780 BLANSHARD - REHABILITATION + ADDITION

HAV00034 CONCURRENT WITH REZ00825

Bubbled areas indicate revisions compared to the previously submitted plans

DATE	REV	ISSUE DESCRIPTION
2022-02-24	1	REZONING PRE-APPLICATION
2022-06-01	2	OPEN HOUSE PROGRESS SET
2022-06-21	3	REZONING APPLICATION
2023-03-23	4	HAP & REZONING RESUBMISSION

EAST ELEVATION

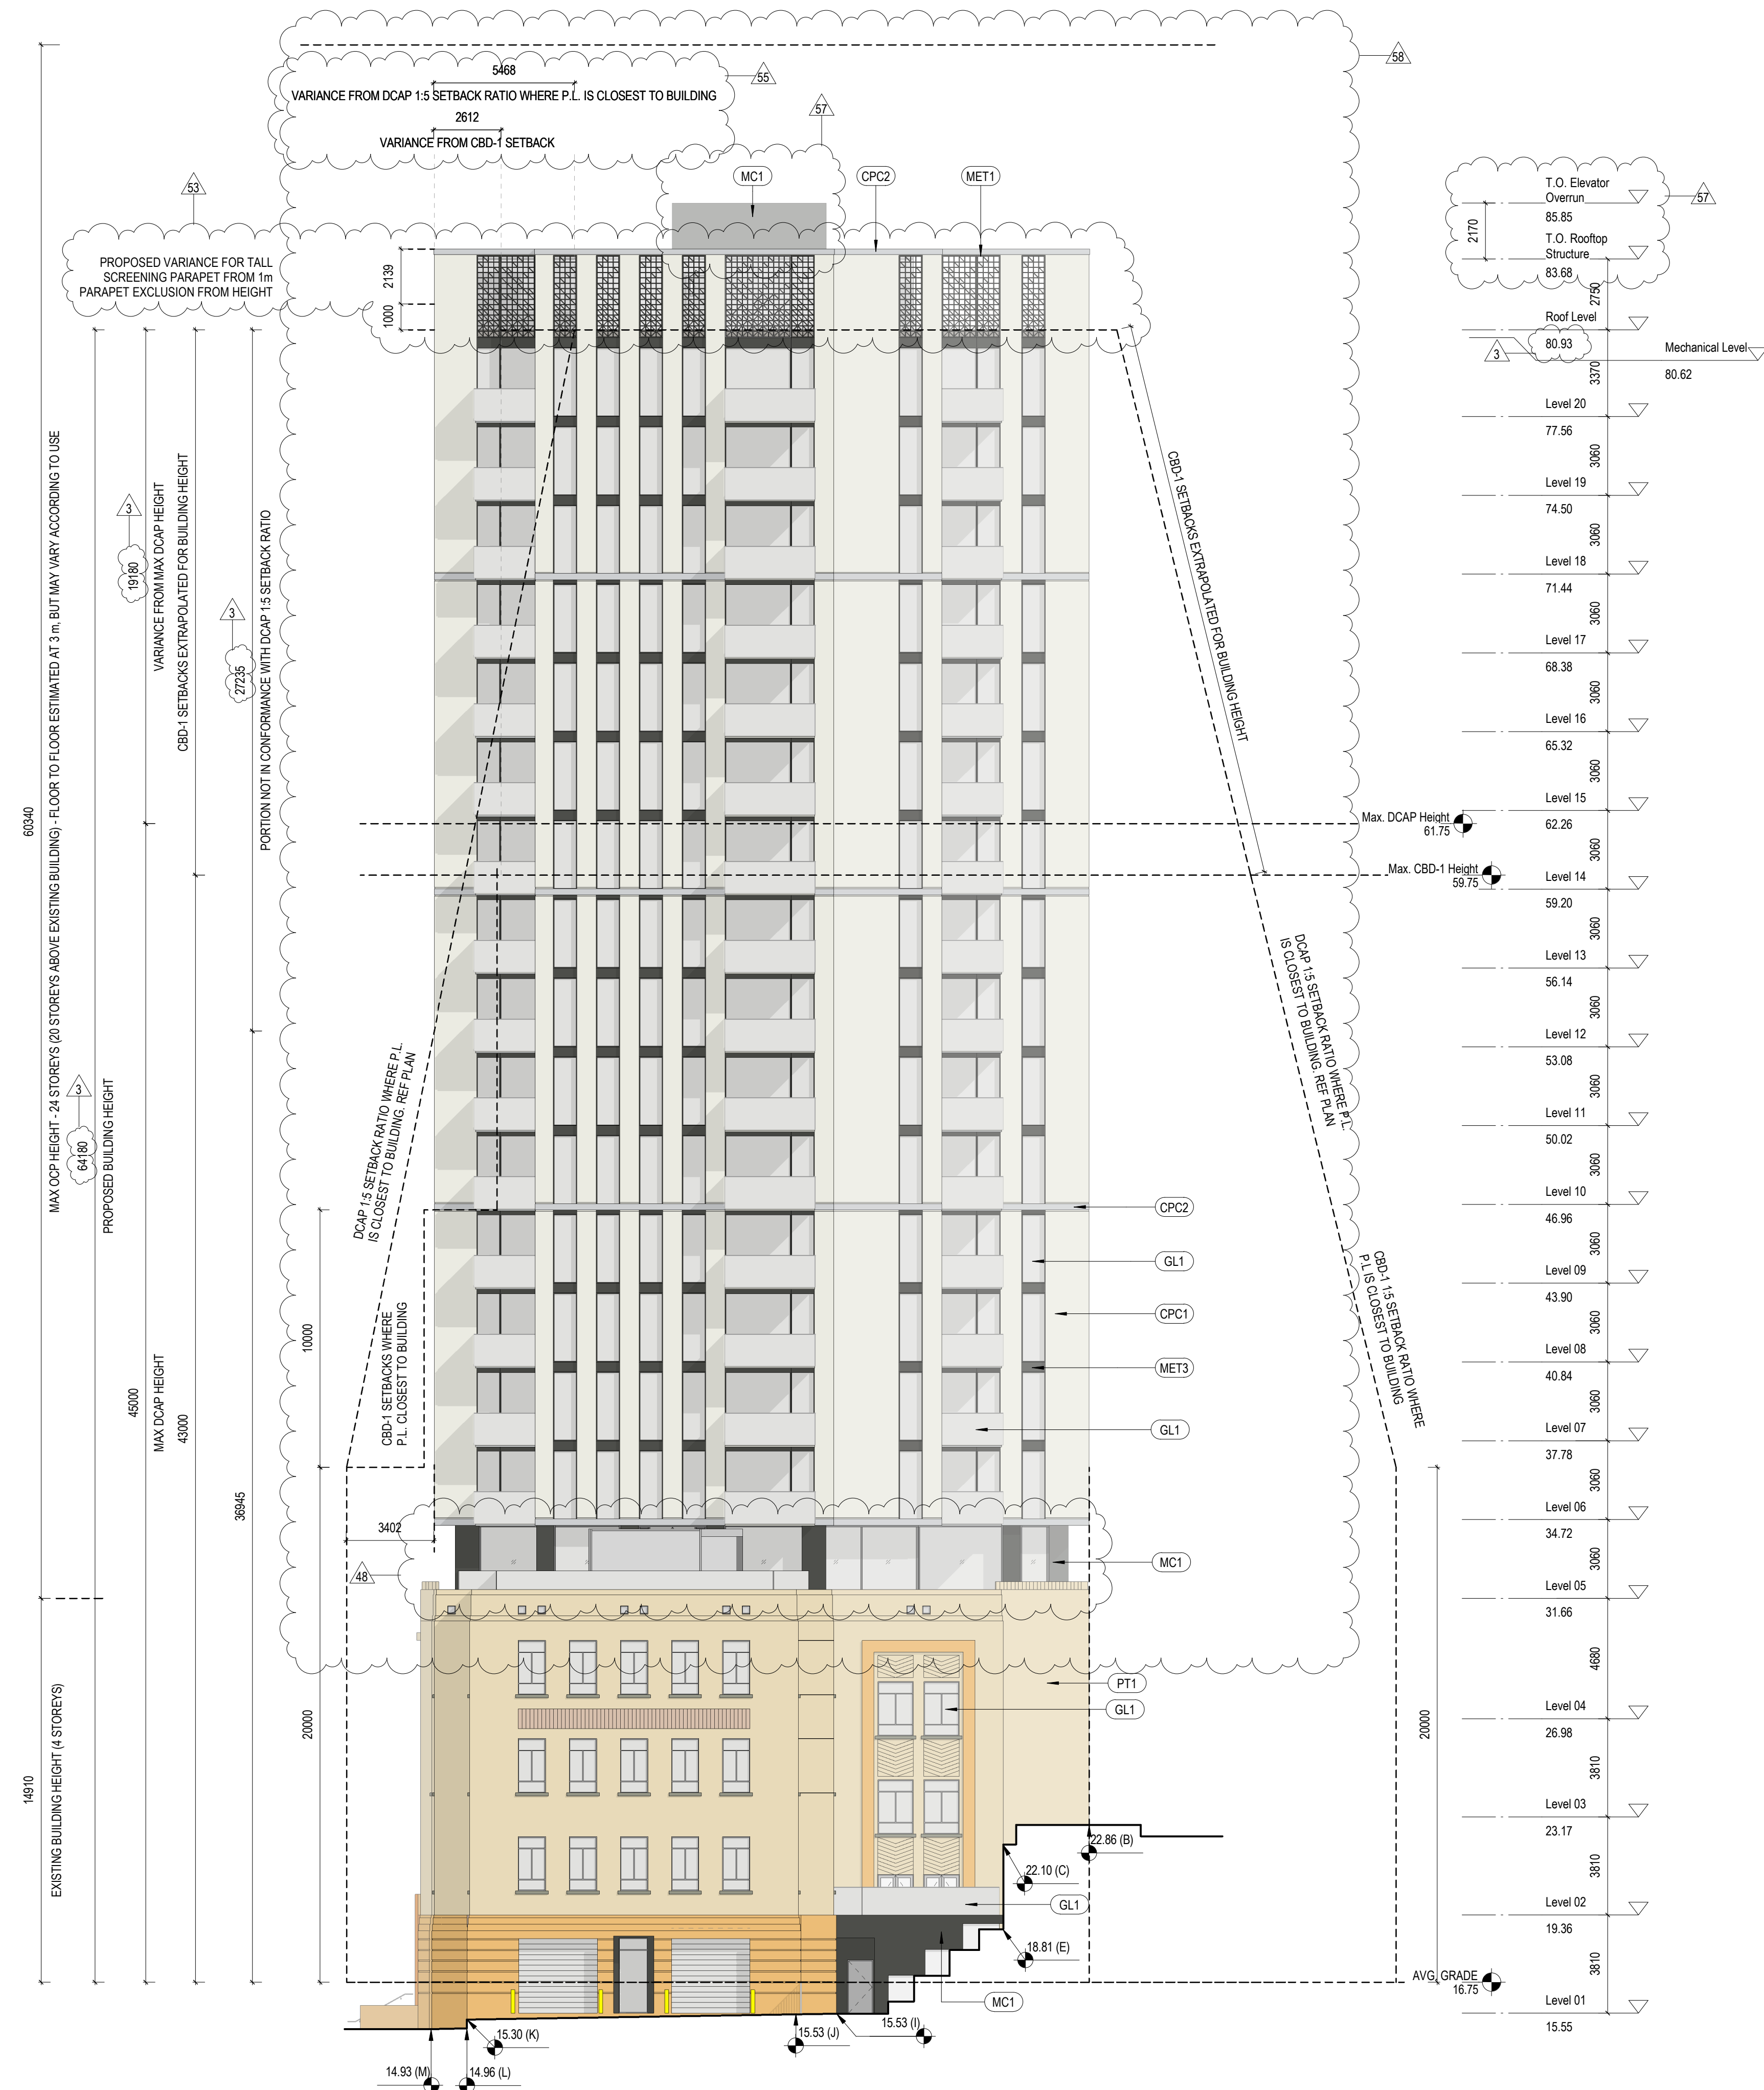
3 Building Height reduced in response to ARS Comment #22. See additional analysis, rationale, and visualizations in Response Letter Sections 10 and 11 of the Large Project Supplementary Information Booklet.

48 The inset face of the glazed facade at Level 05 has been updated for the revised building massing and to respond to ARS Comment # See additional visualizations and rationale in response Letter and Sections 10 and 11 of the Large Project Supplementary Information Booklet.

57 For HAP coordination, Elevator access added to mechanical room on Roof, which has increased the height of the Rooftop Structure.
